Re: Additional Variance Information Renaissance Meadows Plat 1

I am providing additional detail for the variance request submitted to the board of adjustment. As part of this submittal I will provide detailed information referencing Section 12A-110.

DETENTION PLAN
 DRAWING NO. C100
 SHEET NO. 01 OF 01

ENGINEER: KKS
DRAWN BY: KKS
CHECKED BY: KKS
SSE PROJECT #: 18061
STORMWATER PLAN
DRAWING NO. C103
SHEET NO. 00 OF 00

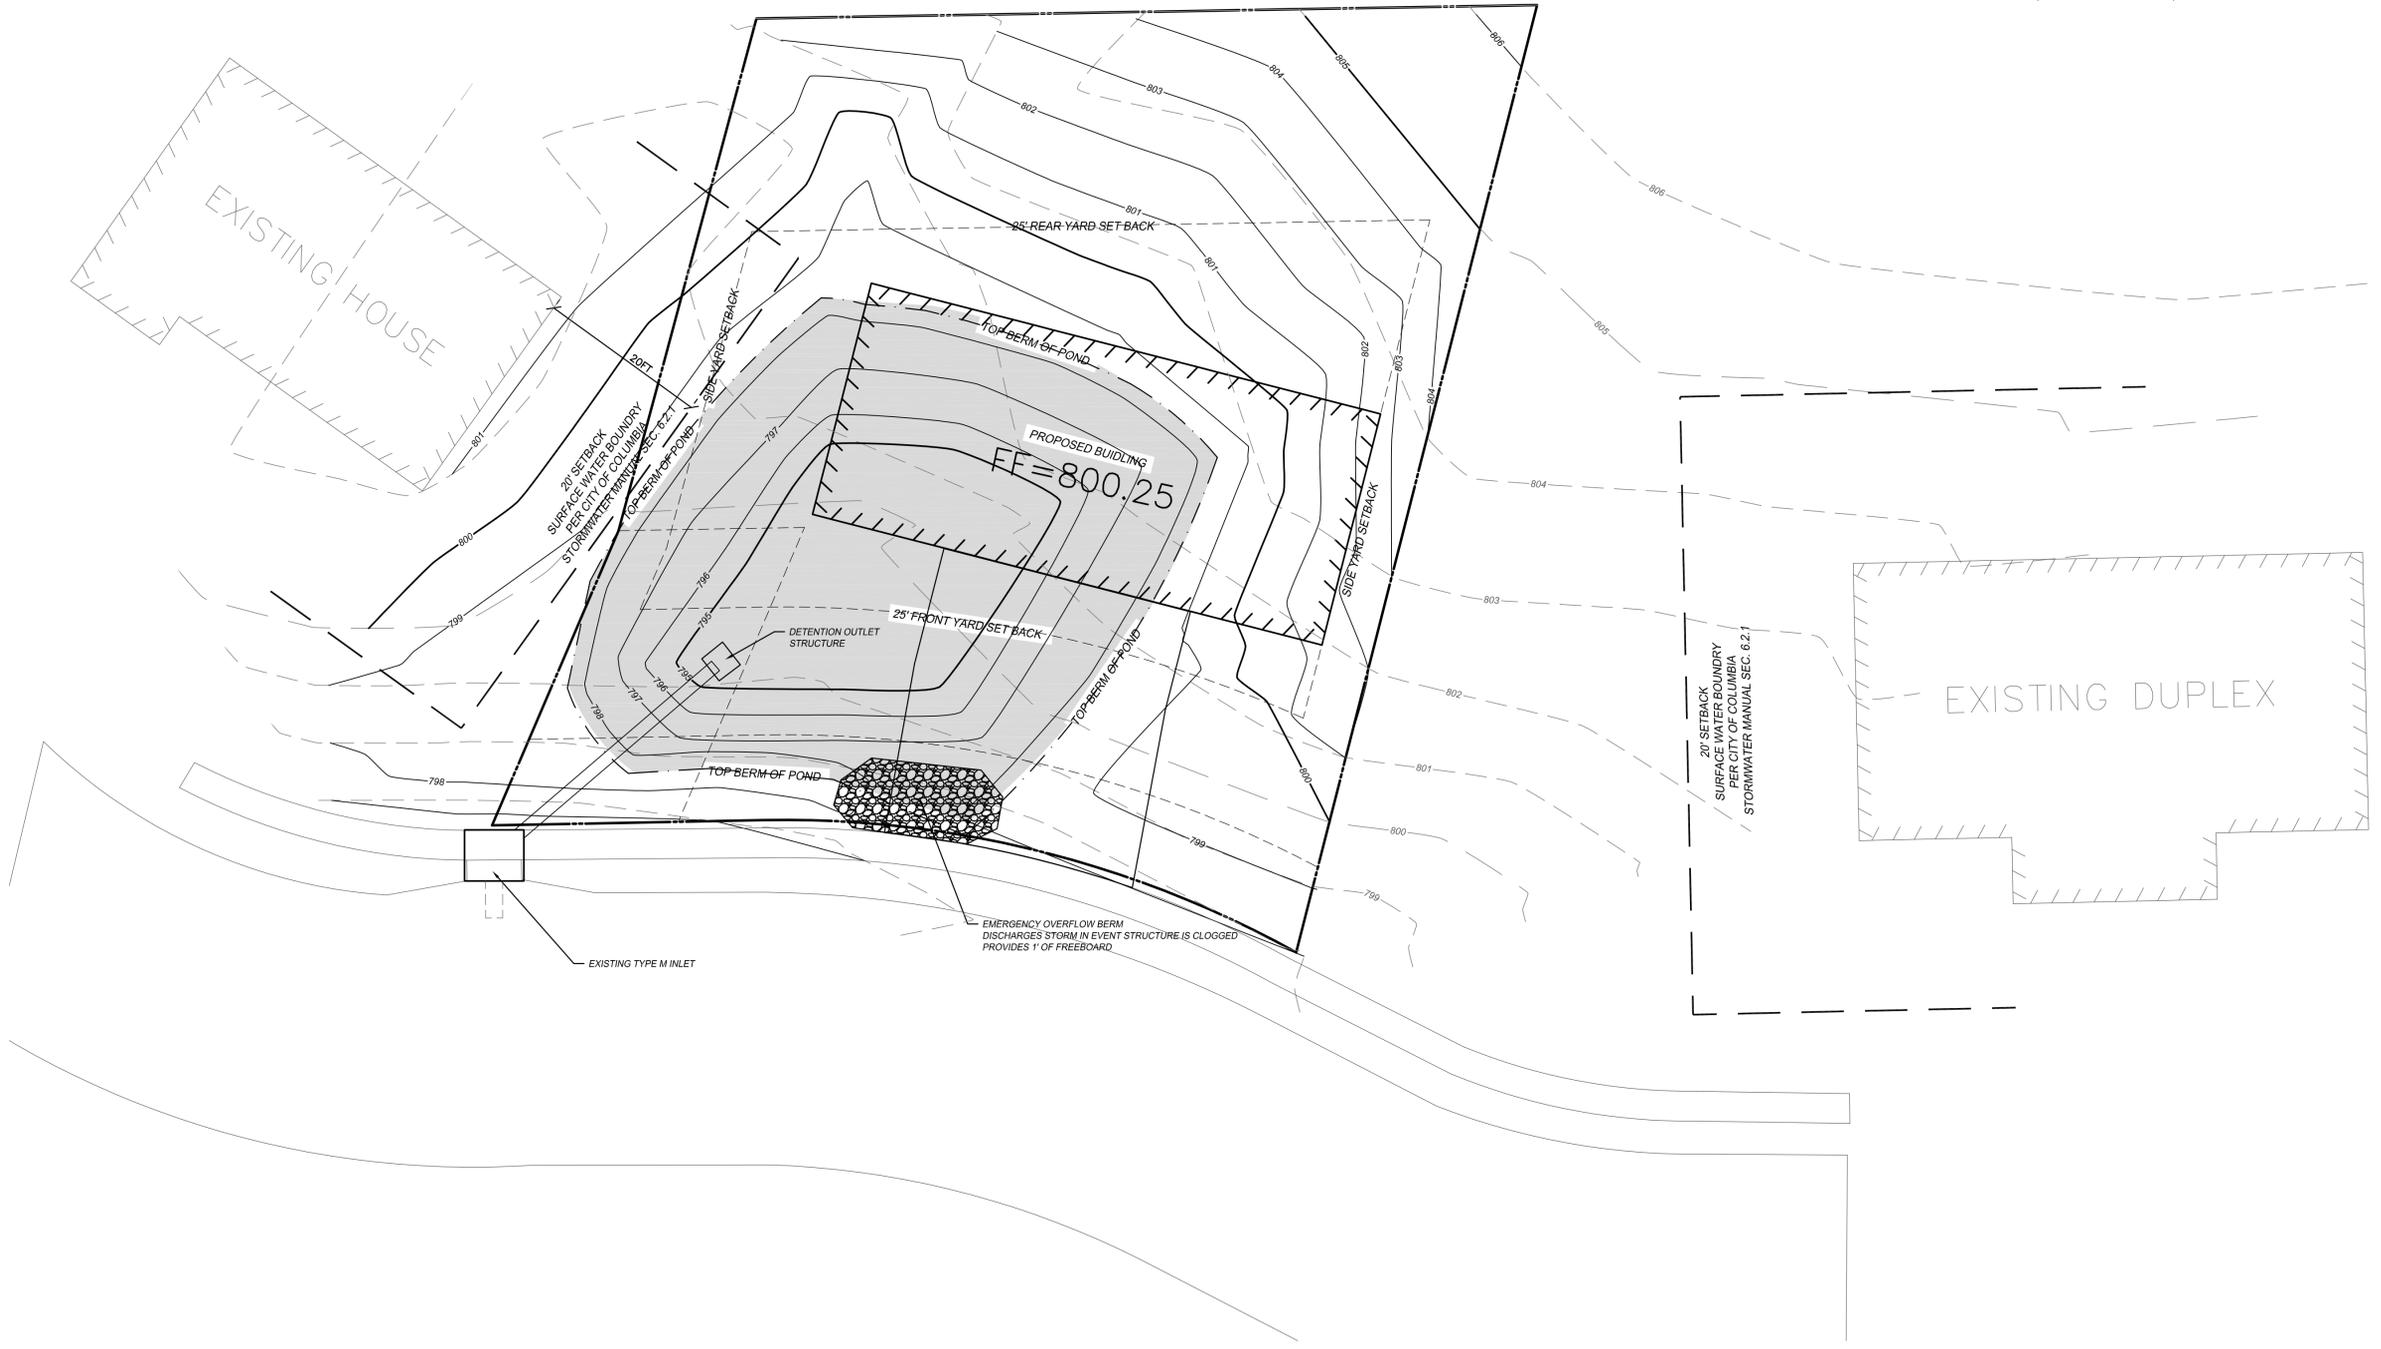
I have provided along with this letter a redesign of the site if required to meet the current City of Columbia stormwater regulations see sheet C100. The existing drainage area that passes through the property creates a condition where the sizing of the detention basin will encompass all of lot 12A. Lot 12A is the site being subdivided and developed and is approximately 9,202sf or .21 acres. This significantly small site and large drainage area to the north creates a hardship for the owner and would be unable to develop the site as proposed on sheet C103.

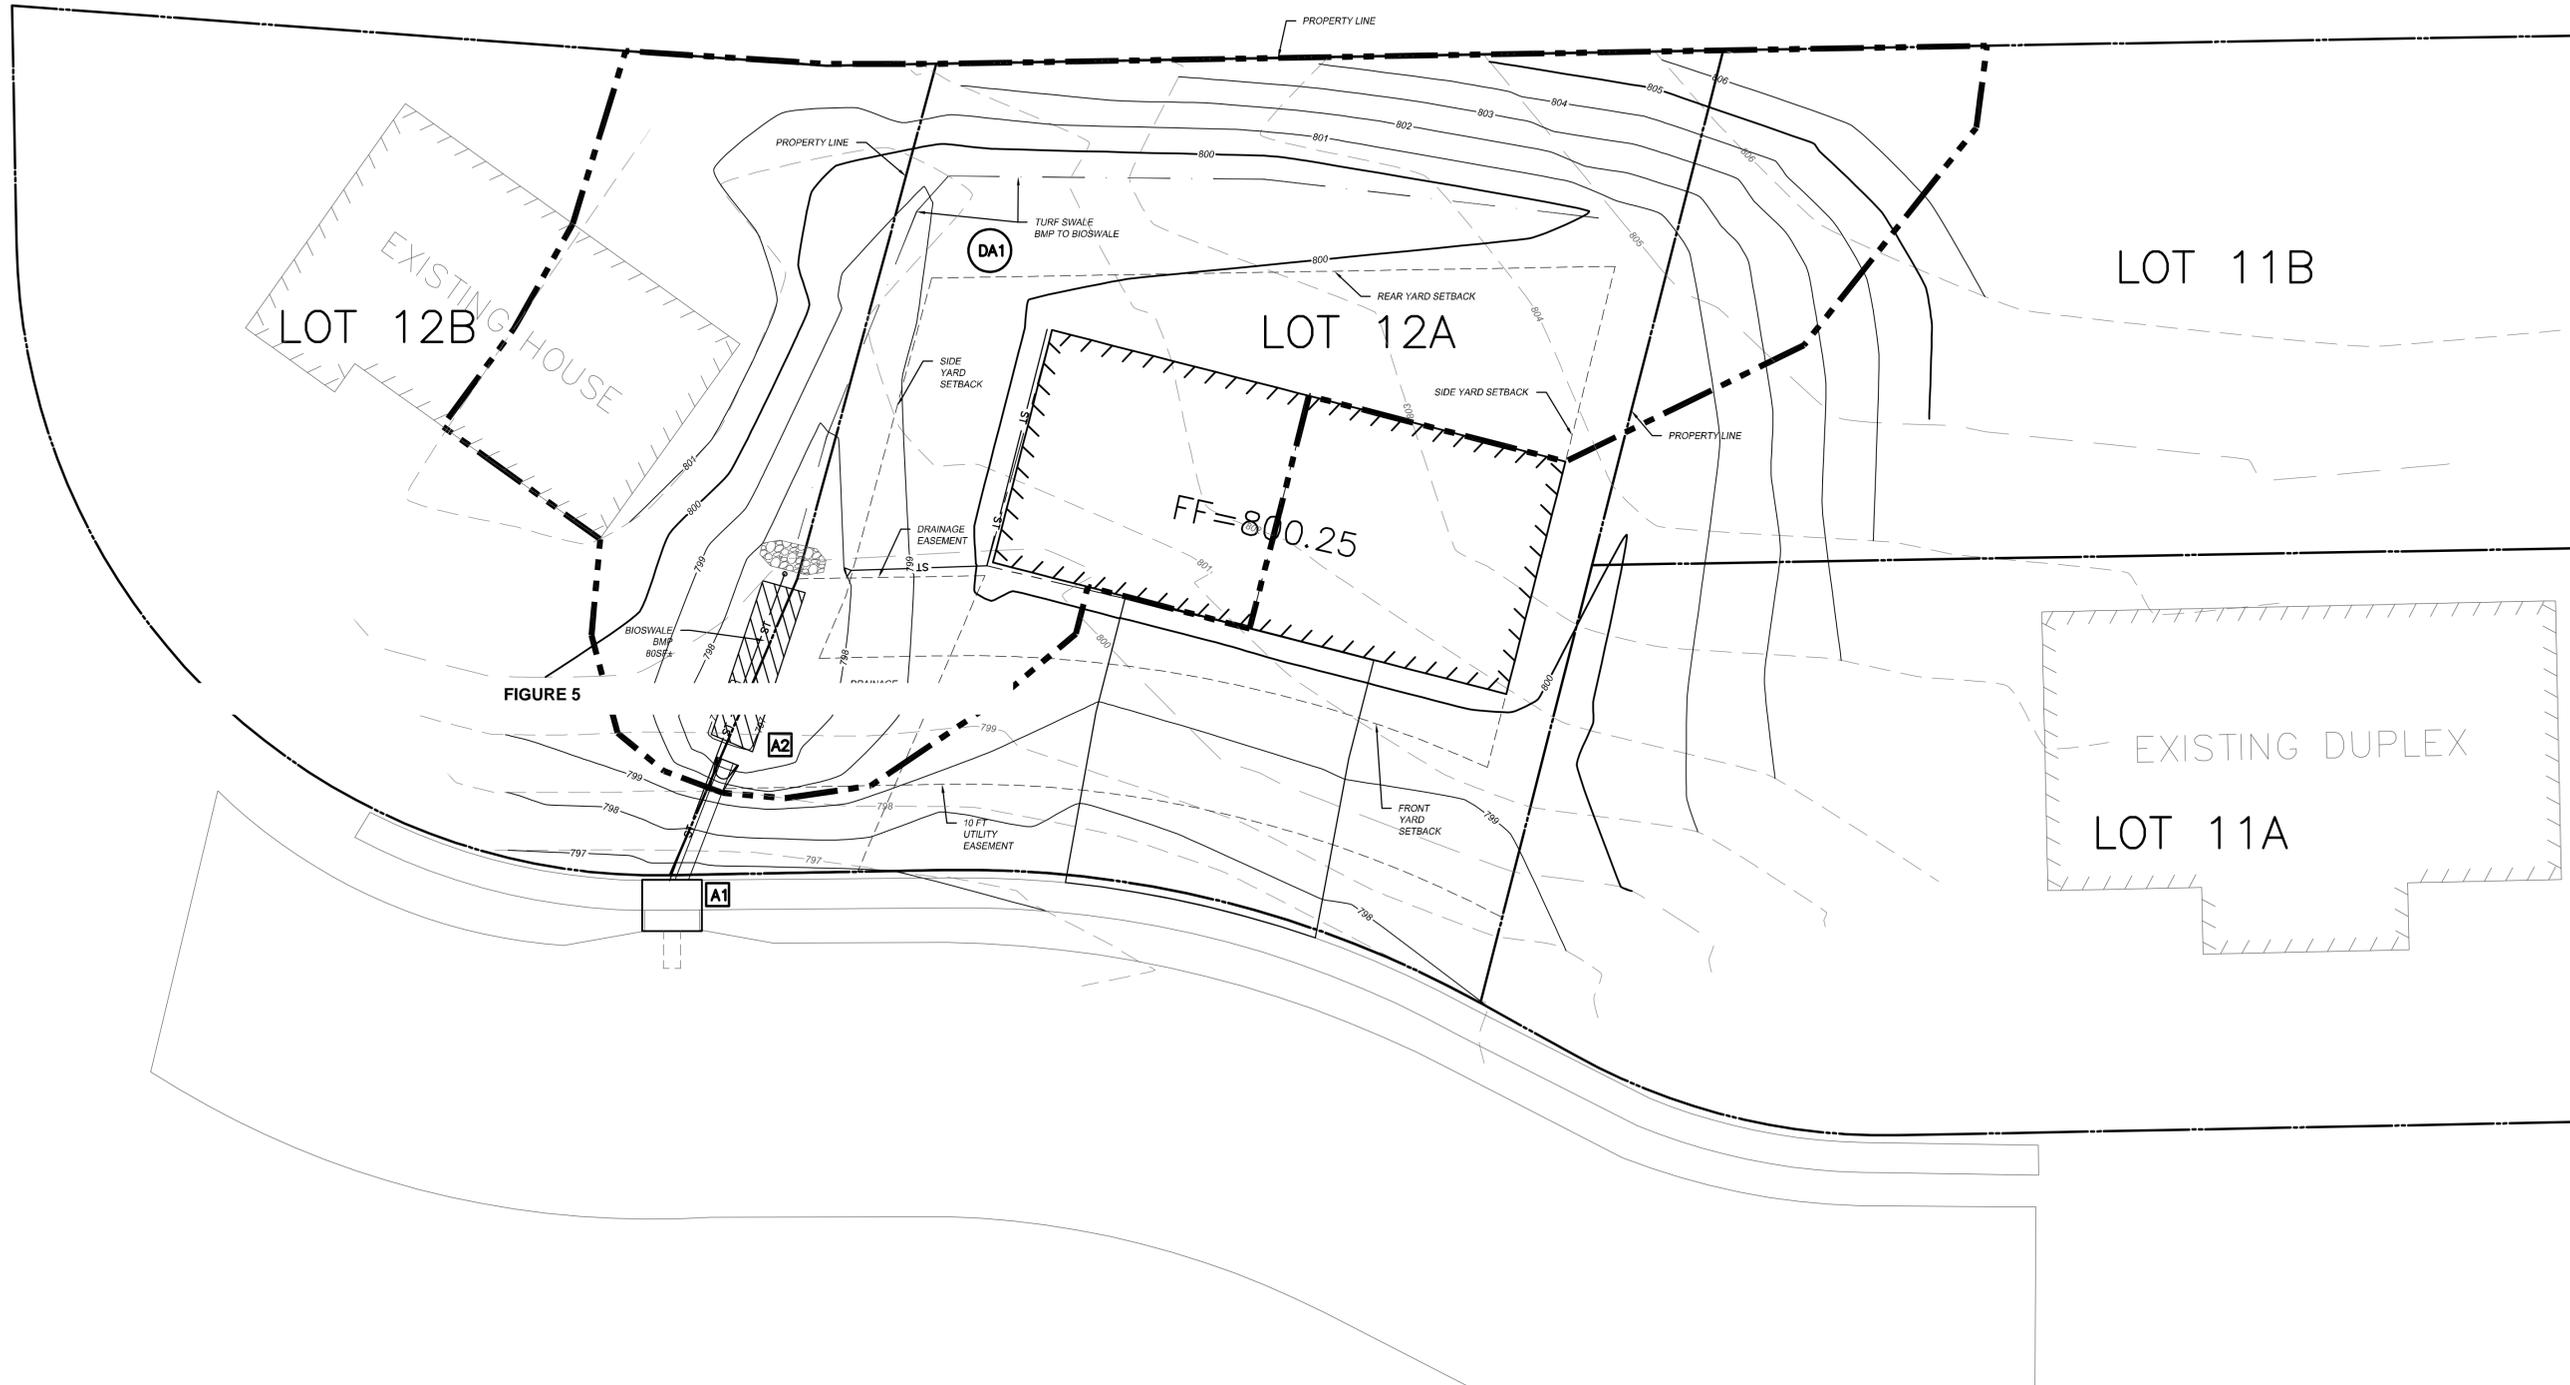
Thanks Keenan.
And what is the size of the bioretention that you plan to install?
Erin Keys, P.E.

It would be approximately 80sf of bioretention material. Proposed BMP shown on display C103 is to be a bioswale.
